TO: T10 Membership
FROM: Paul A. Suhler, Quantum Corporation
DATE: ~~14 January 2009~~ 21 January 2009
SUBJECT: T10/08-409r5, ADT-2: Internet ADT (iADT)

Changes to ADT-2 rev. 5**Markup conventions**

Figure 3 – Example communication sequence diagram

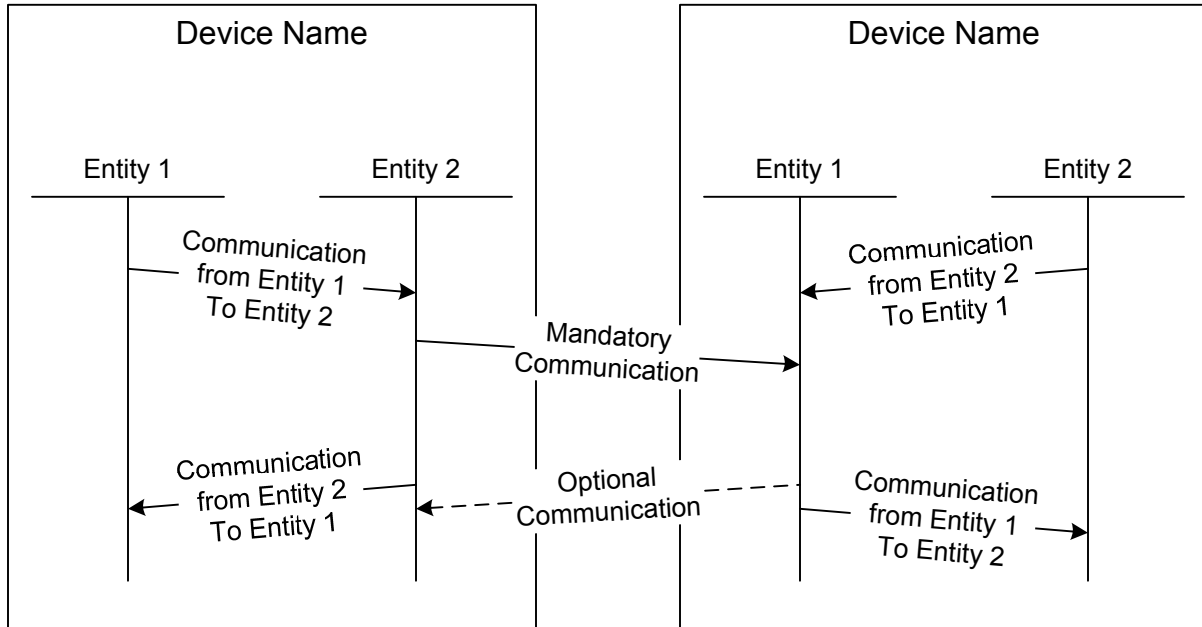
3.6.3 Notation for communication sequence diagrams

Sequence diagrams are used to indicate communication among entities within a device and among devices. All communication sequence diagrams use the notation shown in Figure 3. Each entity is indicated by a horizontal bar with a label on top of a vertical bar. Entities within the same device are enclosed by a box with a label at the top of the box. Each communication is indicated by an arrow with an optional label. Solid arrows indicate mandatory communications and dashed arrows indicate optional communications. Time flows from the top of the diagram (i.e., first communication) to the bottom (i.e., last communication).

Figure 34 — Example Media Changer application of ADT

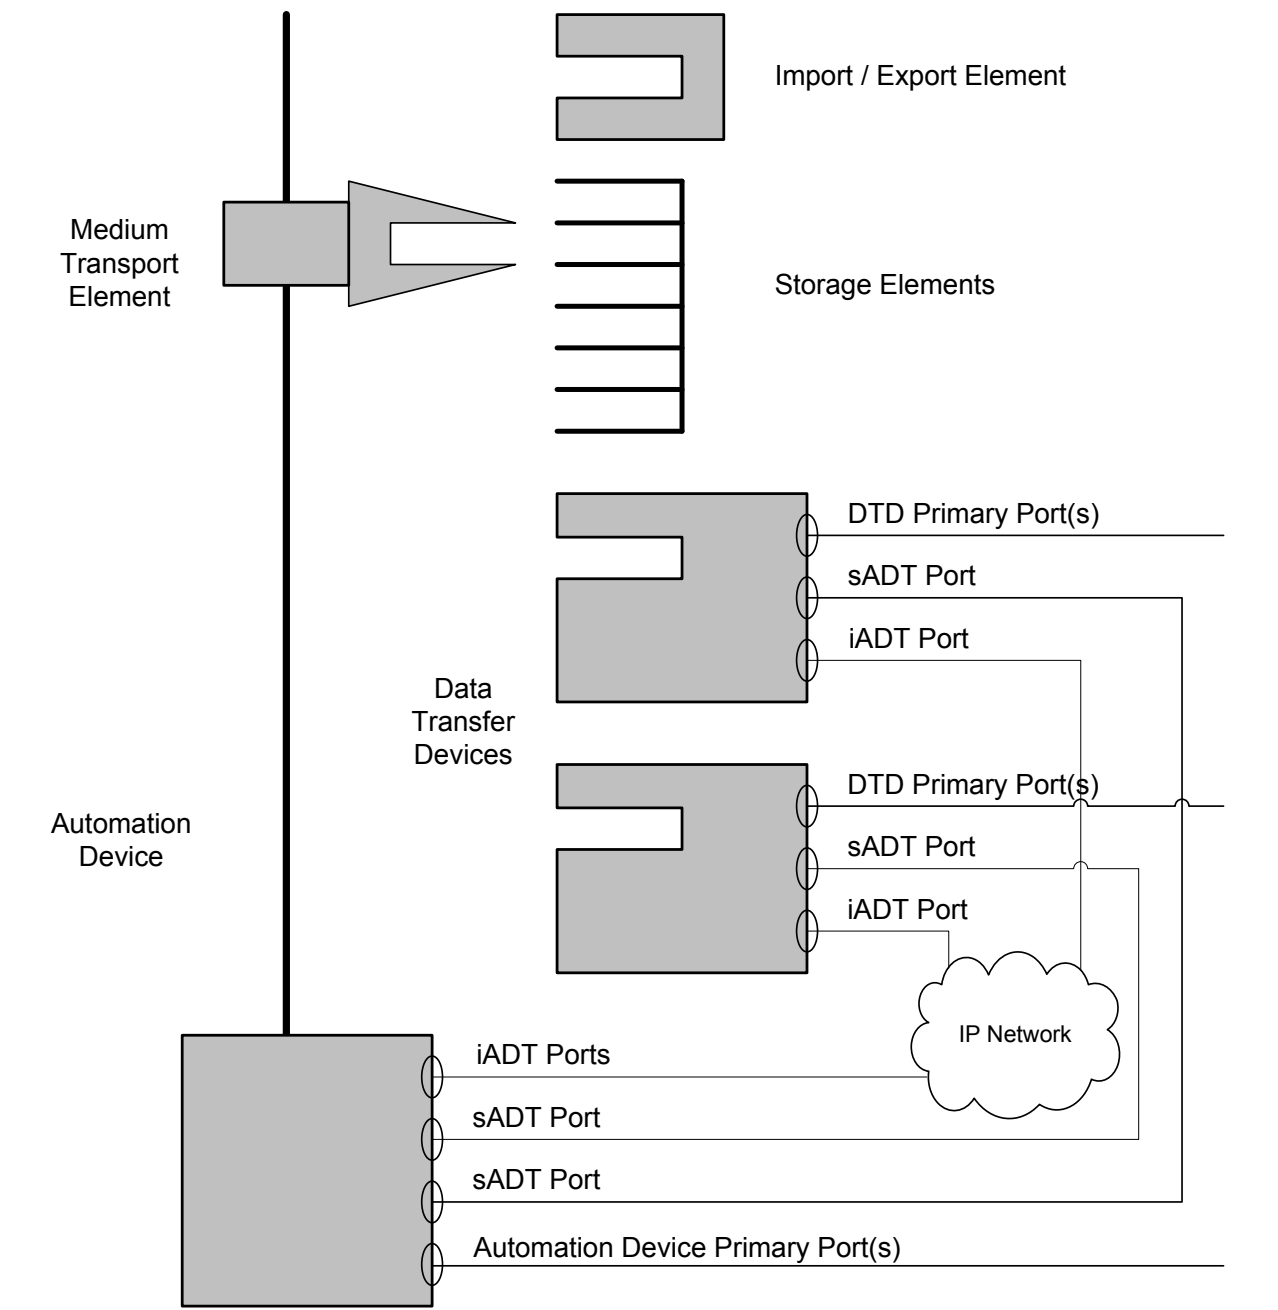
Figure 3 4 shows ~~an example of an ADT interface~~ examples of serial ADT (sADT) and internet ADT (iADT) interfaces (see 4.1.2) within a media changer containing two DT devices. Other common components of a media changer are also shown for reference. The components of an automation device are medium transport elements, data transfer (DT) devices, storage elements, and import/export elements (see SMC-3). The automation device may communicate with the DT devices through ADT ports, as defined in this standard. DT devices and automation devices communicate with initiator ports other than those in the automation device using primary ports.

Replace and renumber Figure 3:

Note: A media changer would not necessarily use both sADT and iADT ports. They are both shown for comparison.

4.3.2.5.2 Transition P3:Logged-out to P0:Initial

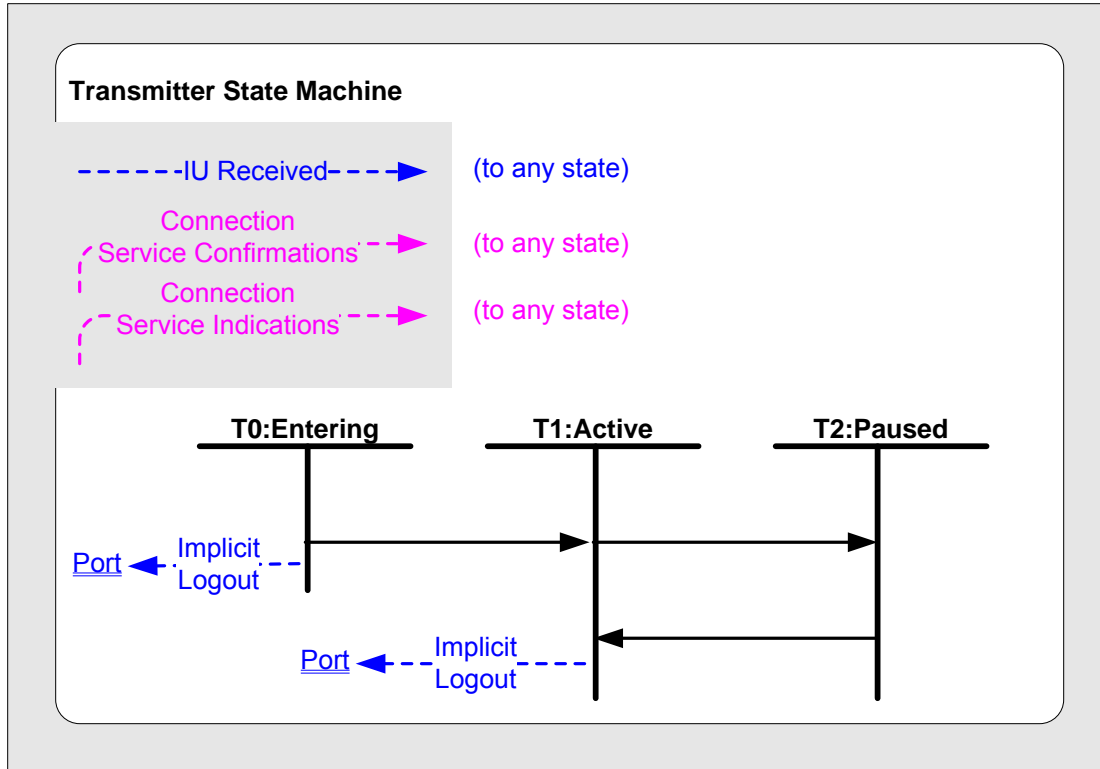
A port shall transition to P0:Initial after the logout duration time ~~specified in the Port Logout IU (see 6.5.5)~~ has expired.

Figure 18a – Connection services for establishing a connection between iADT ports

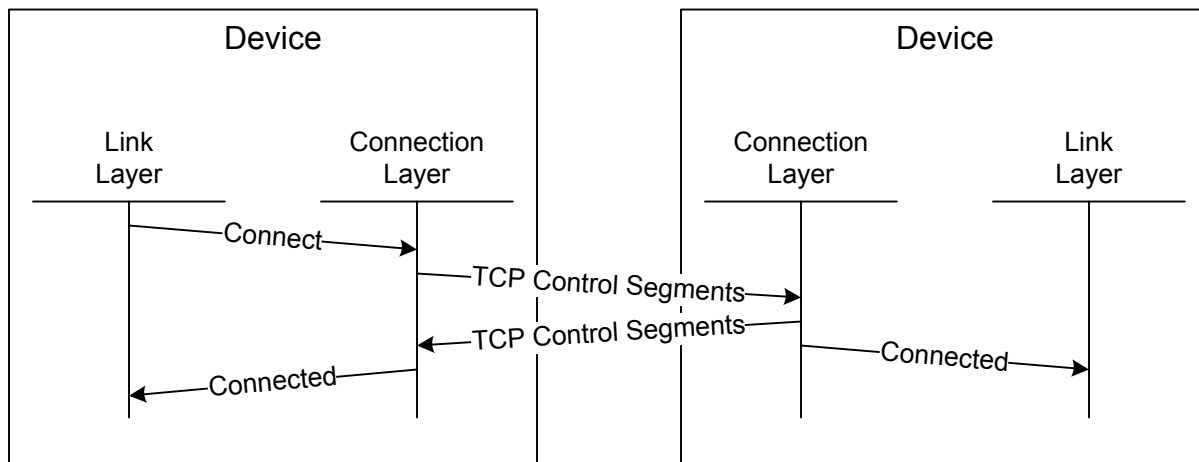
Figure 18a shows an example of the relationships among the connection services used to establish a connection between two iADT ports. The communication between the two devices is defined in RFC 793 and may constitute more than the two communications shown.

Figure 20a – Connection services for closing a connection between iADT ports

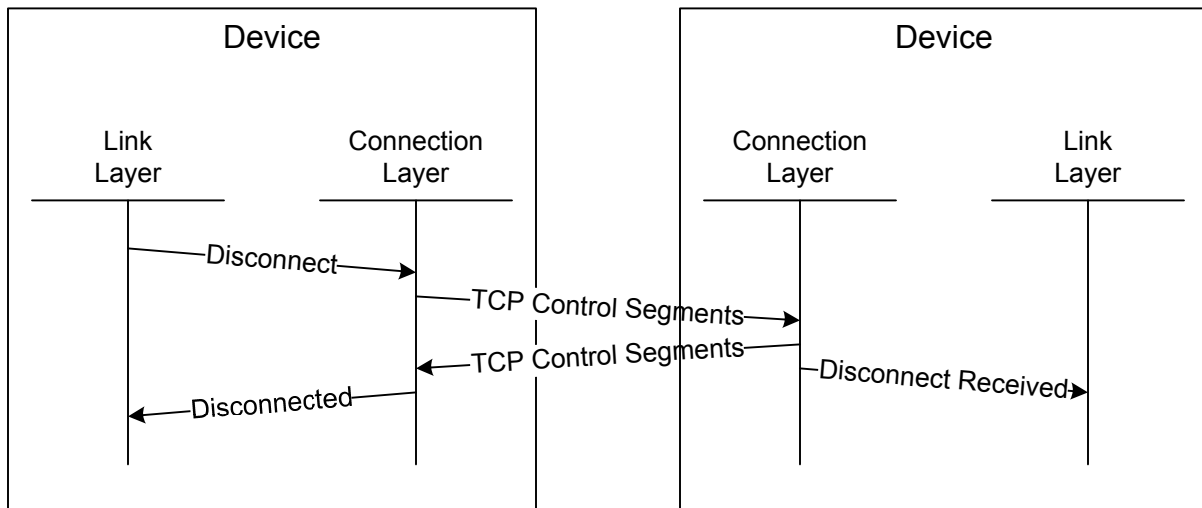
Figure 20a shows the relationships among the connection services used to close a connection between two iADT ports. The communication between the two devices is defined in RFC 793 and may constitute more than the two communications shown.

An iADT port closes a connection by invoking the **Disconnect** service request. ~~An iADT port shall attempt to transmit any Any~~ characters that have been ~~successfully~~ submitted for delivery by earlier **Send** service requests ~~will be transmitted~~ before the connection is closed. When an iADT port receives a **Disconnected** service confirmation or a ~~Disconnect received~~ **Disconnect Received** service indication, the connection is closed and no more characters shall be received. iADT ports exchange TCP control segments in order to close the connection.
